ACP ref: 322154-25

Re: Response to Further Information Request in relation to An Coimisiún Pleanála Ref. 322154-25, for the Proposed Briskalagh Renewable Energy Development, Co. Kilkenny.

Response to Further Information

**ADDITIONAL AND AMENDED
PLANS AND DETAILED
DRAWINGS**

DRAWING TITLE:
**Proposed Riparian
Planting**

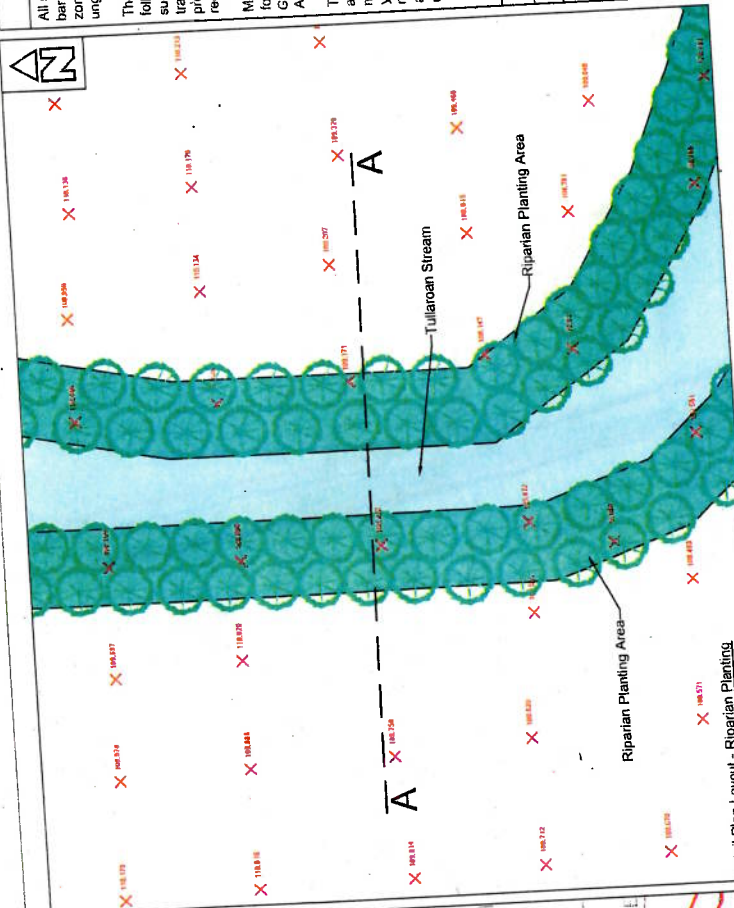
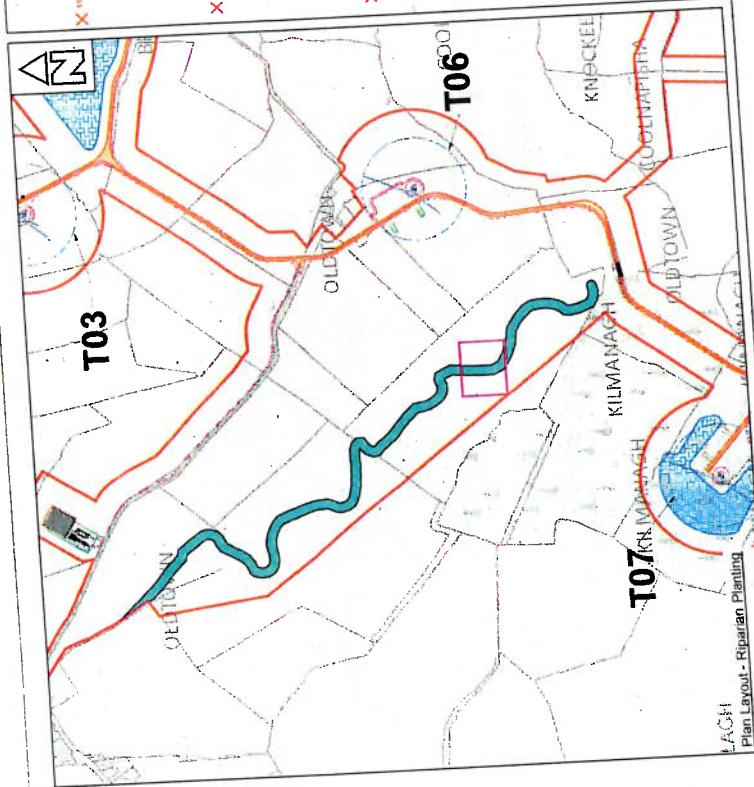
You are requested to submit an indicative landscape plan and section diagram for the proposed riparian buffer along the Tullaroan Stream (known locally as the Kilmanagh/Tullaroan River). This plan shall provide details of the proposed planting and protective fencing (if required).

Please see drawing 230502-78FI of Appendix 2 for an indicative landscape plan and section diagram for the proposed riparian buffer.

Species mix to be finalised in conjunction with the project ecologist.
